Re: MOE Comments Hidden Quarry

We are pleased to respond to the comments provided by the Ministry of the Environment. We have attached the original MOE comments in Appendix A and have not duplicated the comments in the text of this report.

Hydrogeologic Impact Assessment
 Proposed Aggregate Extraction
 Part of Lot 1, Concession 6
 Township of Guelph/Eramosa, County of Wellington

Figure R3:
Precipitation Totals Comparison with Streamflows

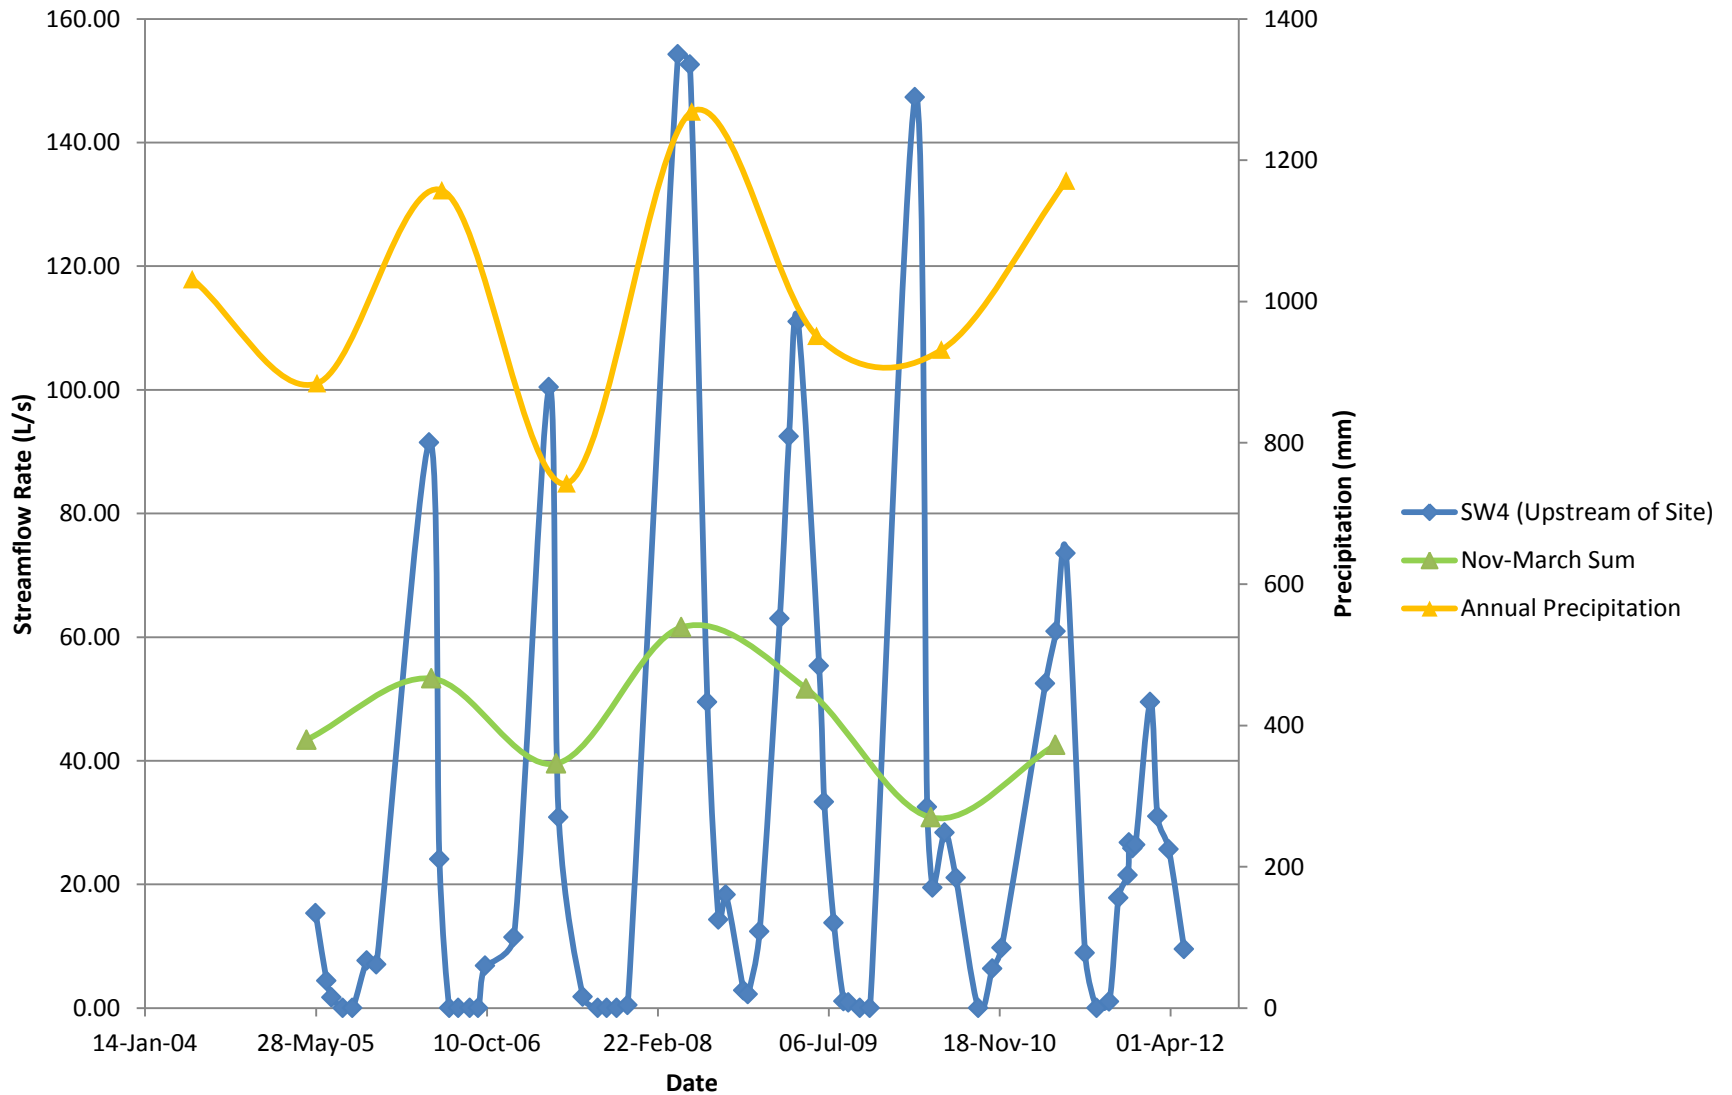
SWC4) Detailed analysis of Streamflow in Tributary B and water levels in Northwest Wetland

Figure R3 compares both annual precipitation rates and November to March cumulative precipitation rates to streamflow measured at SW4. There is no apparent correlation between annual precipitation rates and flow in Tributary B. There is no apparent correlation between November to March cumulative precipitation rate and flow measured at SW4. Thus, although precipitation is the ultimate source of water in Tributary B, there is no readily identifiable correlation between monthly flow and monthly precipitation.

Figure 5: Precipitation Versus Northwest Wetland

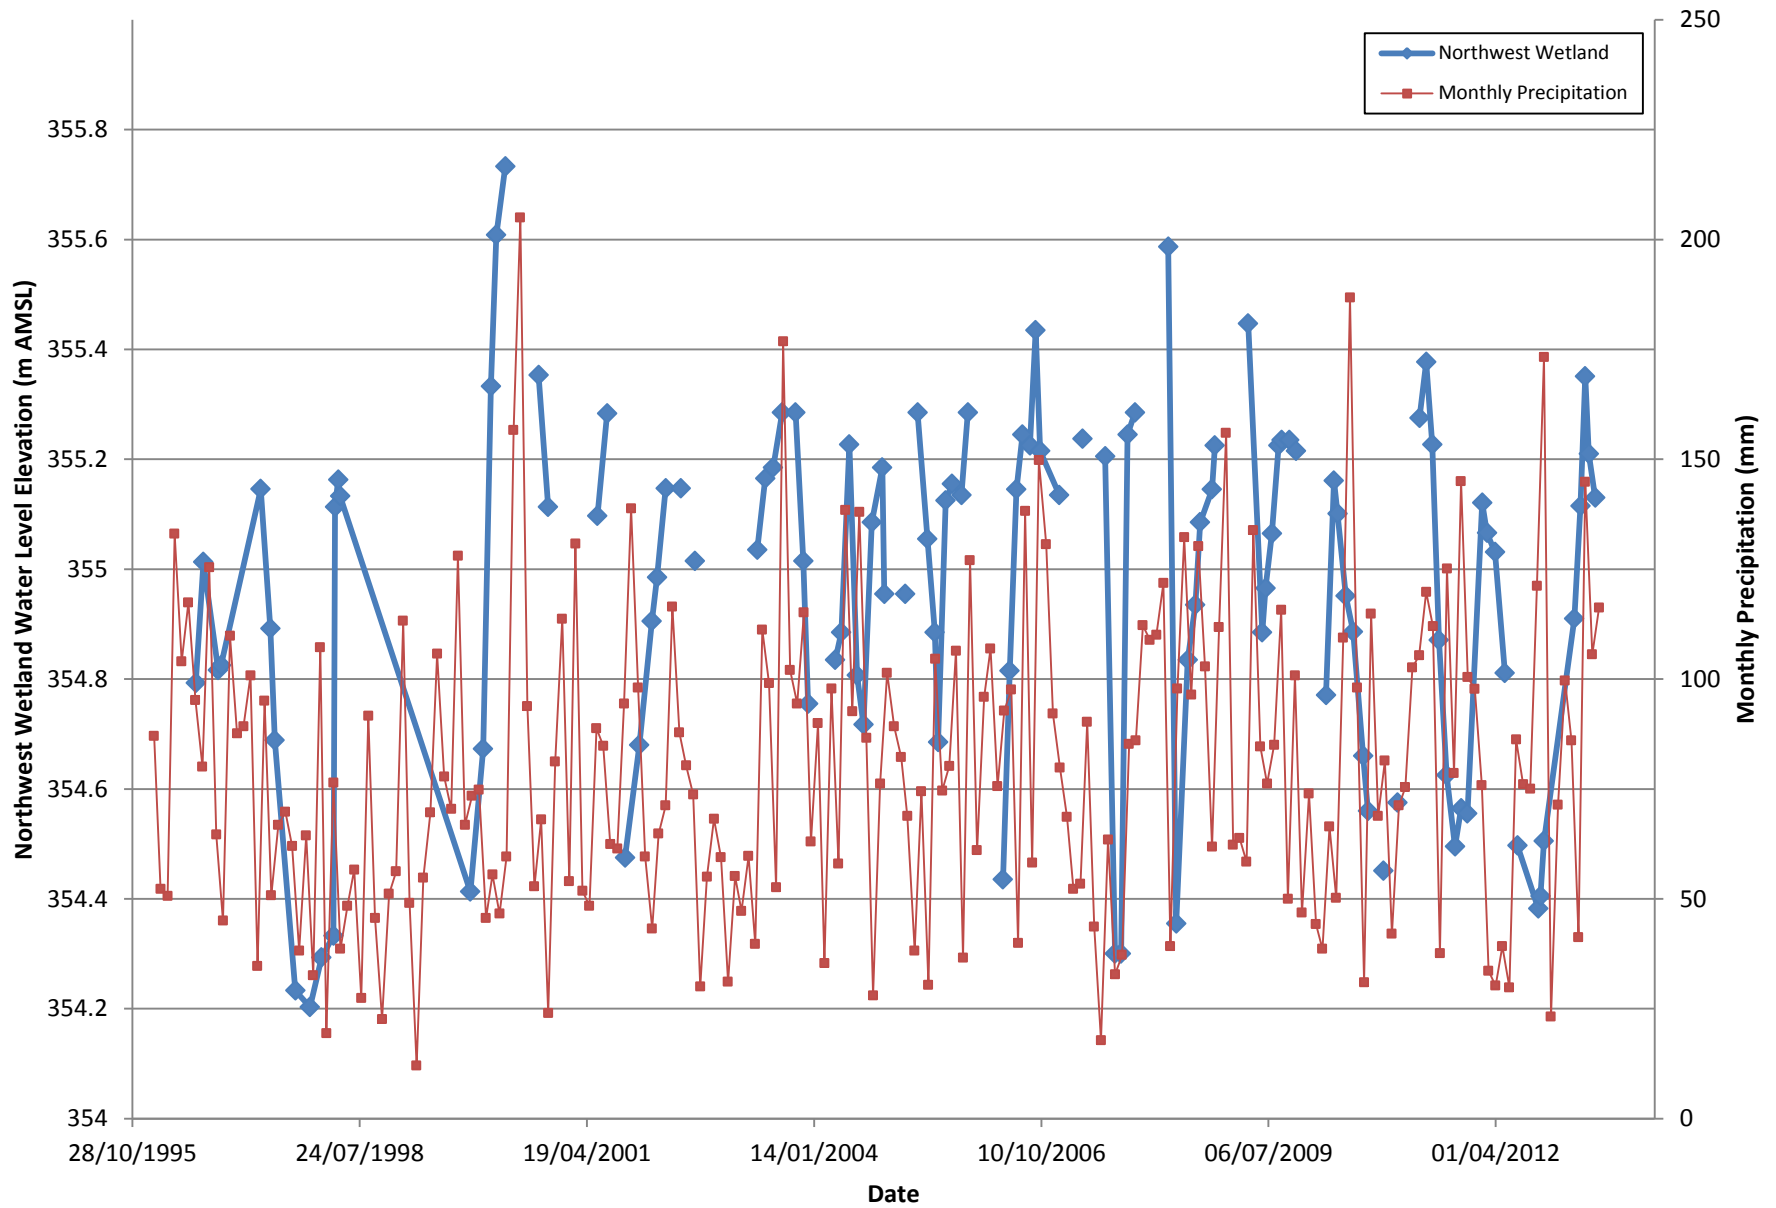
Northwest Wetland

Figure 5 compares surface water levels in the northwest wetland to precipitation. The water level has historically ranged from 354.2 to 355.68 m AMSL. Other than seasonal fluctuations (spring highs - fall lows) there is no season over season trend to the data. These seventeen years of historical data will be used to compare water levels during and post quarry development.

We are recommending an annual trigger value of 354.20 m AMSL. The warning level is established at fifteen centimeters above the trigger level or 354.35 m AMSL. The water level in the wetland falls about fifteen centimeters per month during summer months. This would provide approximately four weeks of enhanced monitoring to determine if there are quarry related impacts. Manual water level measurements will increase to bi-weekly if the warning level is exceeded.
